Group submission relating to application SSD 5878

Sydney International Convention, Exhibition and Entertainment Centre Precinct –
Mixed use Development in the Southern Haymarket Precinct (Concept Proposal) (SSD)

DEVELOPMENT APPLICATION
 PEAK TOWER - NORTH ELEVATION
 PROPOSED BUILDING PROFILE OVERLAY

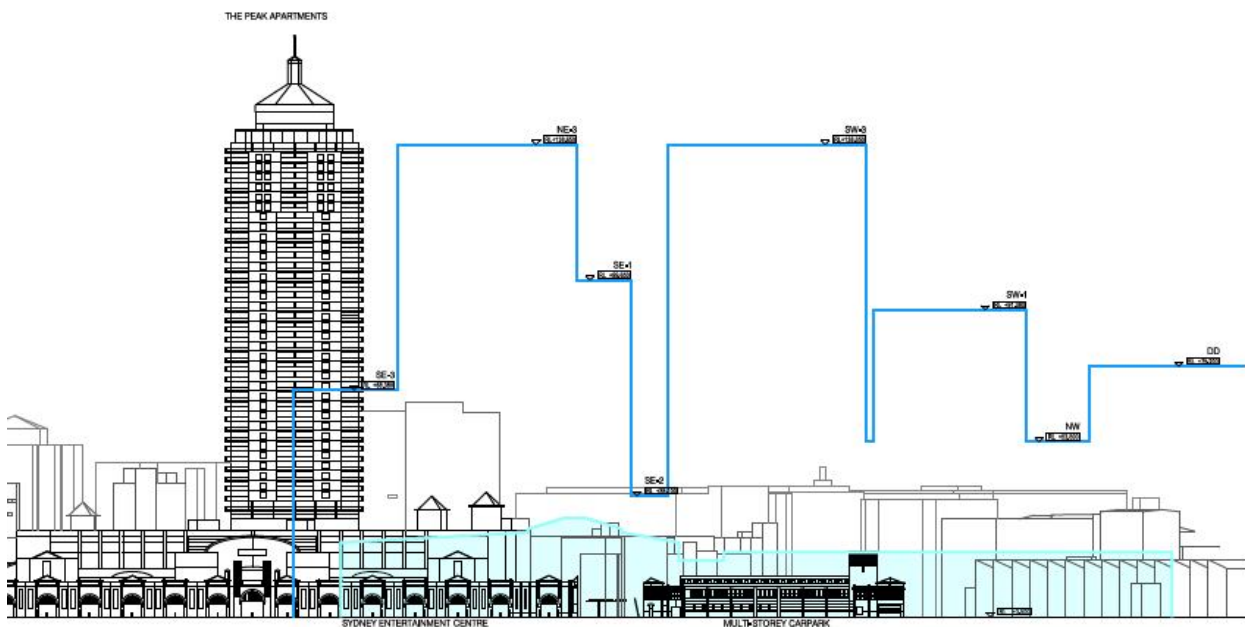
This shows these planning guidelines have been ignored in the drive for increased density and optimum placement of the new towers for maximum return - all with scant regard for the existing buildings.

The loss of amenities, outlook and views is an excessive burden on the residents of the Peak and for all the residents of surrounding buildings. At a minimum, it is imperative to delete the Tower SE1 from the planned development.

The following figure – buried in SSD 5755 illustrates the size of the proposal in relation to The Peak.

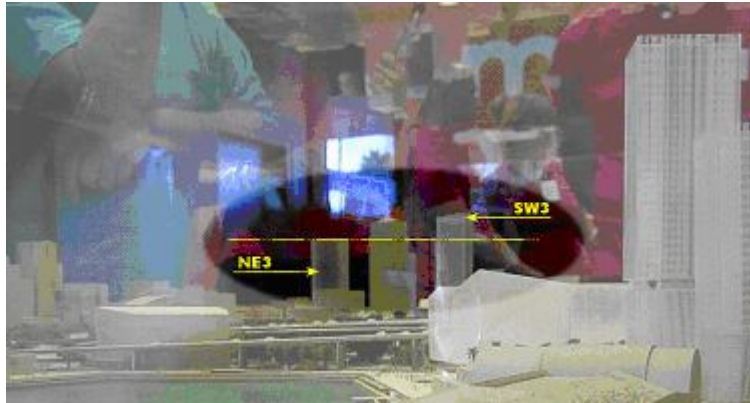
- *Views to the Powerhouse Museum will be affected by the two residential blocks in the Haymarket Precinct situated next to the Rail Corridor, which will also be impacted. Principal views to the Powerhouse Museum are available from Harris Street and will not be affected by the proposed development, while views to the building are of secondary importance.*

The student blocks and tower SW 1 will obscure the sight lines to the Museum from the southwest and the CBD. Why is it deemed sufficient to retain only the western façade when the eastern façade is the most important one.

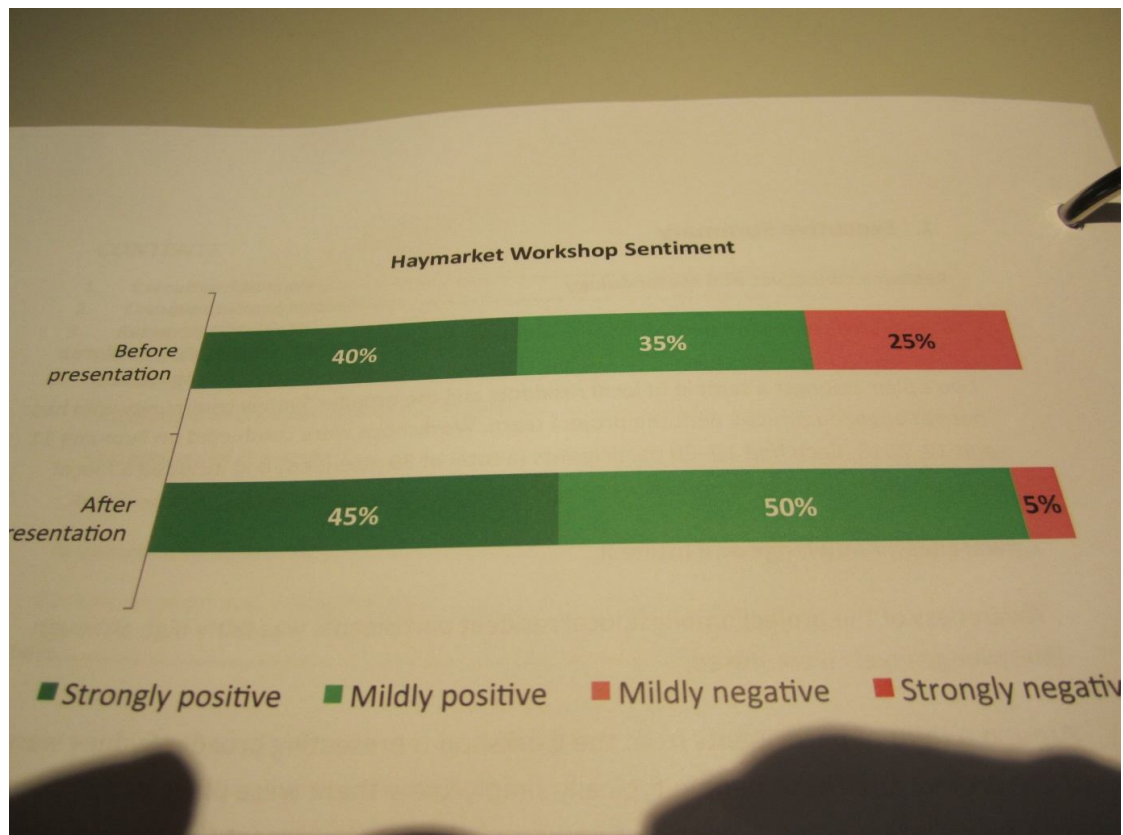
The information given during consultation was very much smoke and mirrors. The statements given on the height of the towers was vague and variable with the number of floors being defined from the podium level in some cases. The RLs of the top of the towers were not disclosed prior to the EIS being lodged. In fact tower NE3 grew about 8 floors after consultation. This is clear from photos of the original model.

It is claimed that 'mildly negative sentiment after presentations was reduced by 20%.' This is not the impression of those who attended the meeting. Many walked out in disgust when it was fairly blatantly put to them that this was the deal and you could have your say when the DA was posted.
